**COUNTY OF SAN MATEO
PLANNING AND BUILDING DEPARTMENT**

SUBJECT: EXECUTIVE SUMMARY: Consideration of a Non-Conforming Use Permit, Design Review Permit, and Coastal Development Permit for the construction of a 417 sq. ft. second floor addition and a 168 sq. ft. rear deck and stair addition to an existing 1,286 sq. ft., one-story single-family residence, where the project encroaches 0.24 of an inch into the minimum 5-ft. left yard setback, located on an existing, non-conforming 4,900 sq. ft. legal parcel at 584 Kanoff Avenue, in the unincorporated Montara area of San Mateo County. The project is not appealable to the California Coastal Commission.

County File Number: PLN 2015-00209 (Sage)

East Elevation

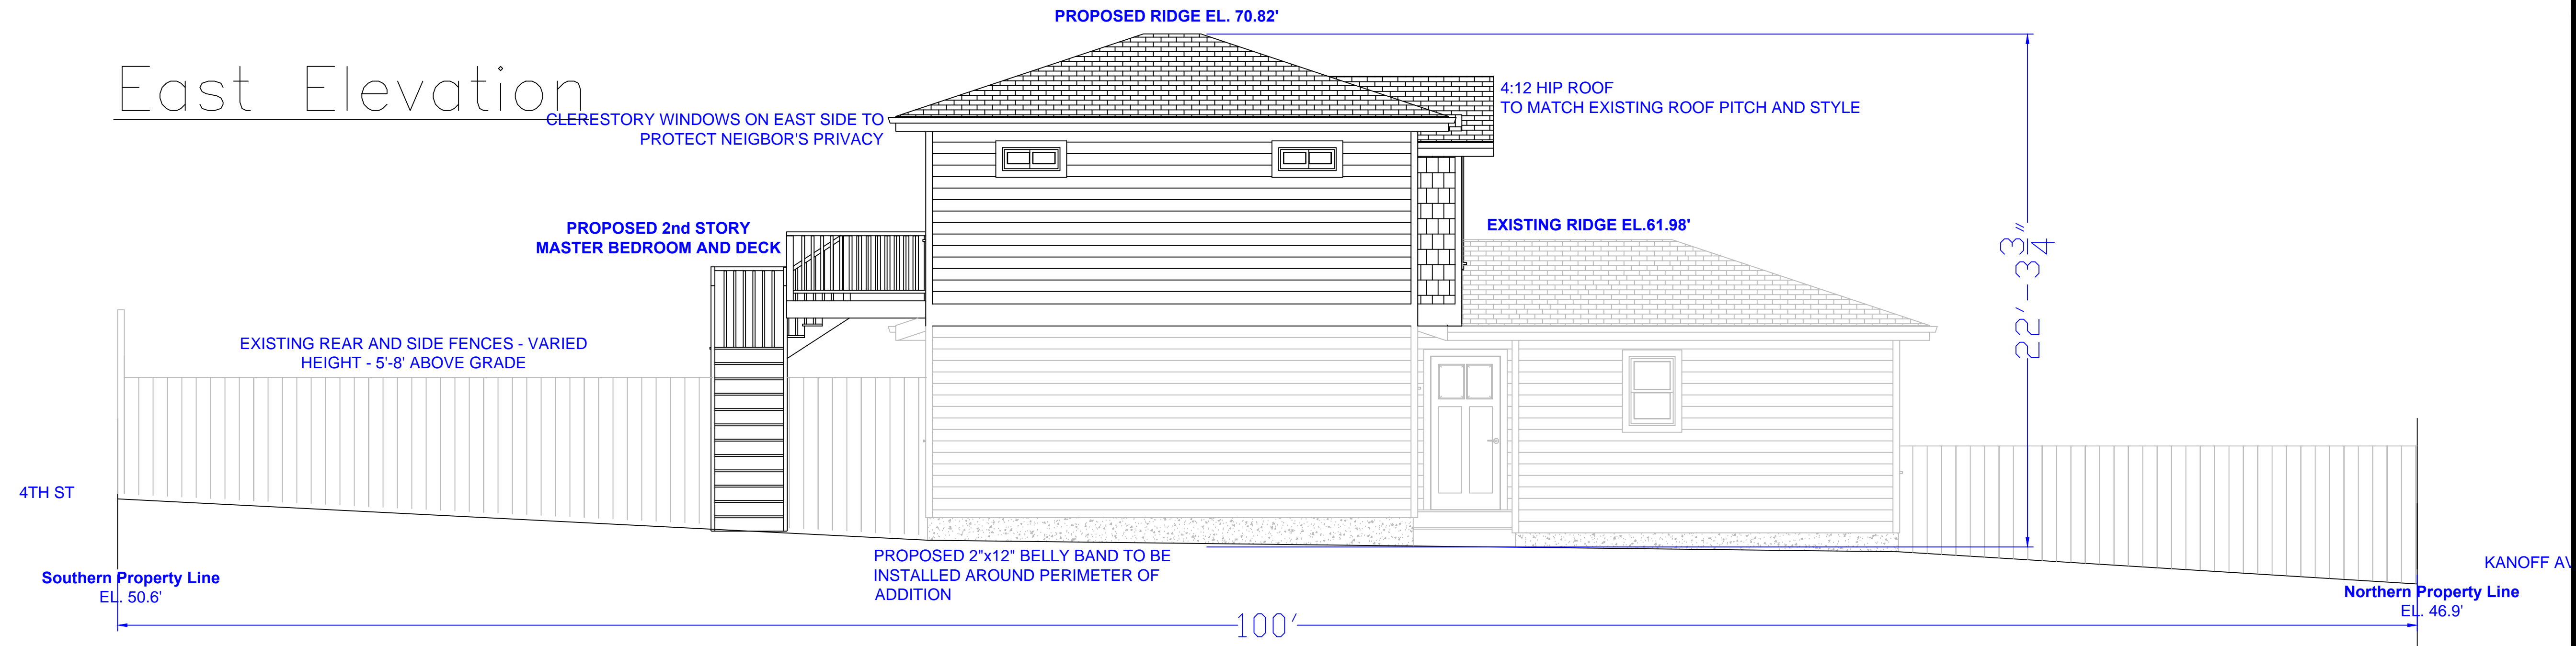
- a. Use Hardie board shingles on the second floor east elevation.
 - b. Use "Elephant Skin" color on the exterior of the second floor.

- c. Use “Vintage Linen” color on the second floor pop-out window to match the first floor.
 - d. Add windows to create a line of windows on the second floor east elevation.
